CAPITAL STREETS | MEMORANDUM

Manning Boulevard Improvement Project

Capital Streets’ Analysis (08/27/23)

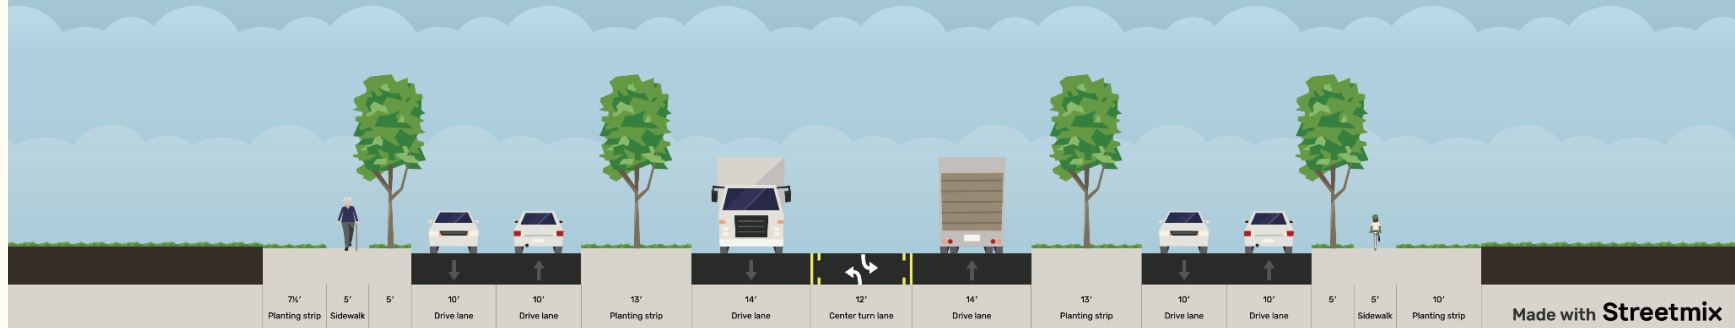
Concept A - Bridle paths become one-way, with four access points. No dedicated bicycle infrastructure except signage. Manning drive lanes are 12’ wide with 2’ painted shoulders on each side, creating a 16’ roadway on each side of a boulevard down the middle.

Concept B - Bridle paths become one-way, with four access points. No dedicated bicycle infrastructure except signage. In place of a central median, the medians between the bridle paths and Manning are widened to accommodate more stormwater. This leaves Manning as a two lane roadway with 12’ drive lanes with 2’ shoulders (a 28’ wide roadway).

While the concepts presented offer marginal improvements over the roadway’s existing layout, several components of the design must be altered to better impact the community. With over 140’ of right-of-way, the Manning Blvd corridor presents a unique opportunity for Albany to create an especially safe and comfortable connection between two of its most important thoroughfares. Specific improvements needed include:

- a. Research has shown wide travel lanes correspond with increases in traffic fatalities. The City's Bicycle and Pedestrian Master Plan recommends lane widths of 10-11ft. The current design alternatives propose effective lane widths of 14-16ft. This encourages fast moving traffic and prevents the City from adding bicycle infrastructure.

Capital Streets recommendations include:

- Two-way bridge paths with infrastructure like raised intersections to keep vehicle speeds safe
- Separated bike lanes on Manning Boulevard, protecting cyclists from motor vehicle traffic
- Appropriate lane widths on Manning Boulevard: 10.5' with 1' shoulders, to reduce speeding
